| Version: A        |          | X Modification    |
|-------------------|----------|-------------------|
| Date: 23 Septembe | r 2024   |                   |

Module M01 - Draining of the magnetic seal assembly installed on the starter gear on the starter-generator side. Modification TU 234.

### SERVICE BULLETIN No. 292 72 2234

Figure 2 - ARRIEL 2 D

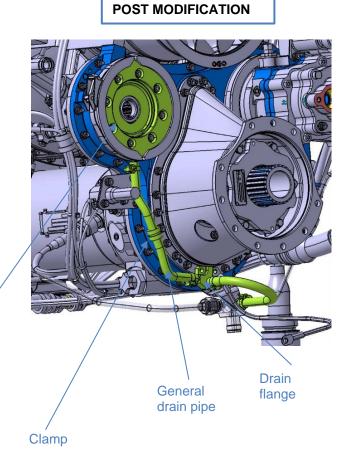
On ARRIEL 2 D, modification TU 234 (see figure 2):

- changes the starter-generator adapter to collect the oil
- adds a clamp and a general-drain flexible pipe to route the oil to the drain flange
- changes the drain flange to install the new pipe.

### Figure 3 - ARRIEL 2 E

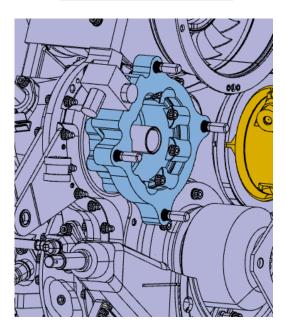
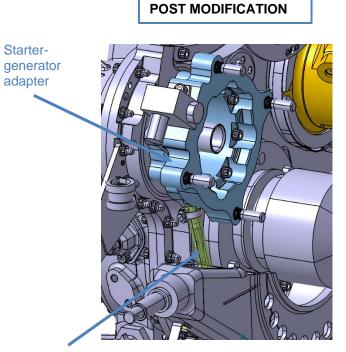
On ARRIEL 2 E, modification TU 234 (see figure 3):

- changes the starter-generator adapter to collect the oil
- adds a general-drain flexible pipe to route the oil to the front support.
